NUREG-0040
Vol. 19, No. 4

Licensee Contractor and Vendor Inspection Status Report

Quarterly Report
October - December 1995

U.S. Nuclear Regulatory Commission

A. Trip Crank for GE Magne-Blast Circuit Breakers

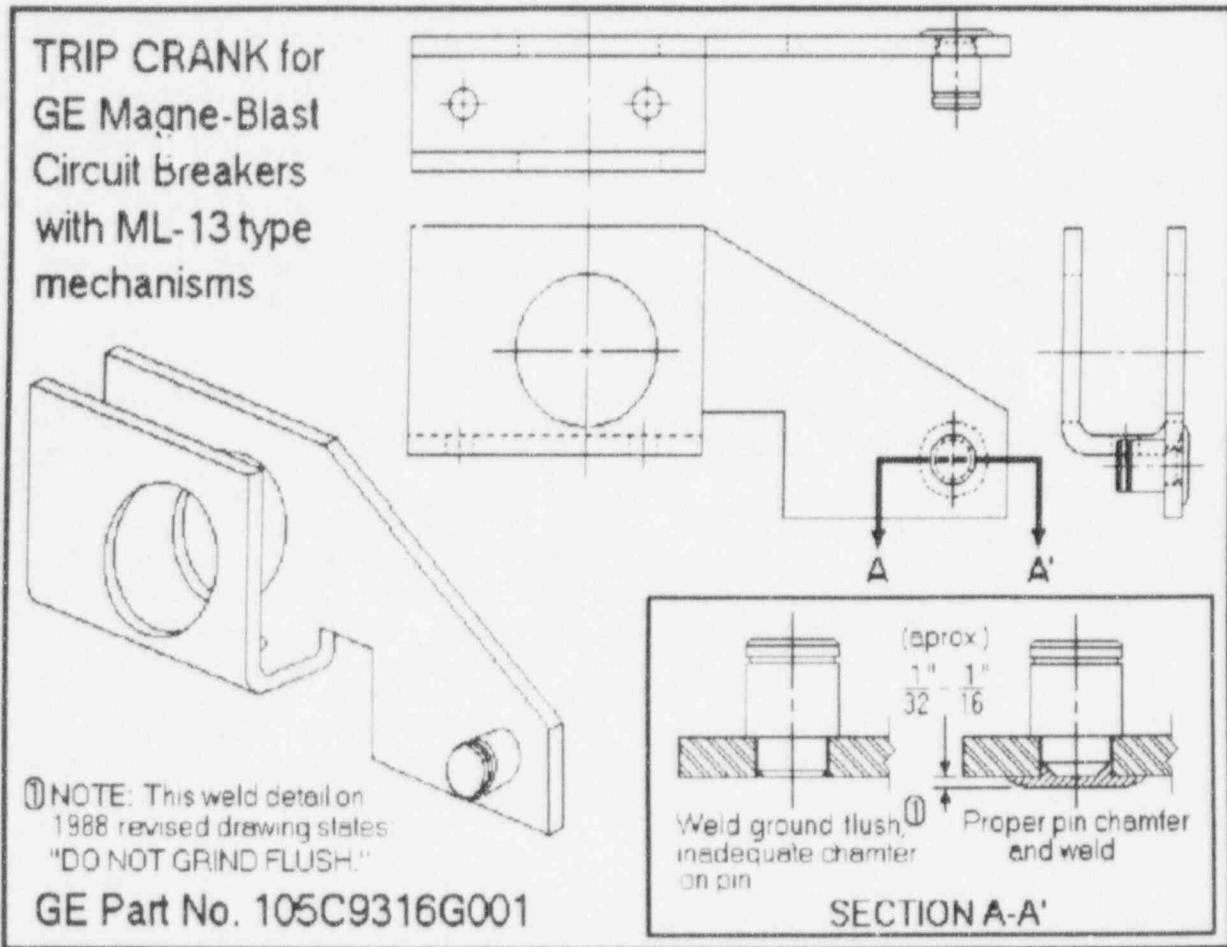
Magne Blast breaker trip cranks had failed on several occasions at the Tennessee Valley Authority's (TVA's) Watts Bar Nuclear Plant (WBN) and one additional failure had been reported at the Shoreham plant. The failure reports to the NRC pursuant to 10 CFR Part 21 were being tracked under NRC Part 21 Report Log No. 93-304. The trip crank is a piece part of the Magne-Blast ML-13 operating mechanism, GE Part Number 105C9316G001. The crank is a stamped, formed and drilled steel plate with a steel pin socket-welded into it (See Figure 1 of Appendix A to this report). The function of the trip crank is to convert the linear force of the trip coil armature or plunger to the torque needed to rotate the breaker trip shaft. Failure of the trip crank could prevent any electrical trip of the breaker. The known failure mode is fracture of the weld that fastens the trip coil armature link pin to the plate portion of the crank under shock loading shear reaction stress on the pin.

In response to the original failures, GE SRP changed the manufacturing process for the crank by requiring some reinforcement (on the weld fastening the pin to the plate) to be left on the back side of the plate and not be ground off. Now specified on the ML-13 drawing (SBP Drawing No. 0105C9316/DCN 083-88-003, May 18, 1988, View "A" weld detail for Group 001 Trip Crank) is: "1/32 TO 1/16 WELD TO REMAIN AFTER GRINDING FLAT SURFACE, DO NOT GRIND FLUSH." The inspectors examined a crank that was in stock at ASD, but tagged for use in non-safety-related applications only. The crank plate was bent at the end and the pin was cocked about 10 to 15 degrees. It appeared that this crank would very likely fail in service, albeit presumably in non-safety-related service, but fail nonetheless.

- No NDE except visual.
- Weld proof test was specified as a 100-lbf minimum static ("dead") load applied "normal to axis." The inspector questioned whether this test effectively simulated or was reasonably equivalent to the severe shock loading reaction stresses generated during operation. The breaker design engineer stated that he had also tested production trip cranks by operation on a shop test breaker and would discuss this method with the onsite PDS staff for dedication purposes.

To ensure that faulty trip cranks are not used in safety-related breakers, PDS is now relying on the 1988 design change and its dedication process to screen out improperly fabricated cranks, as evidenced by, for example, the fact that the unsatisfactory crank found by the inspector had been rejected for nuclear use. Although the amount of chamfer on the small end of the pin that is inserted into the plate and the penetration depth allowed by the depth to which the shoulder is machined into the pin both significantly affect the amount of pin surface area in contact with the weld filler material, these attributes are not specified to be checked during manufacture, as they cannot be seen afterward. The dedication at the time of this inspection relied solely on a 100-lbf static load test and the presence of 1/32 to 1/16 inch of pin weld reinforcement on the back side of the plate. With respect to faulty cranks in the field, SBP is considering issuing a SAL on this problem and in the mean time PDS has put out instructions to the service shops to inspect the cranks as breakers come through for service and replace the cranks as necessary. The inspectors concluded that the vendor's action thus far was satisfactory in resolving this issue, but that it would be complete only with the issuance of a SAL.
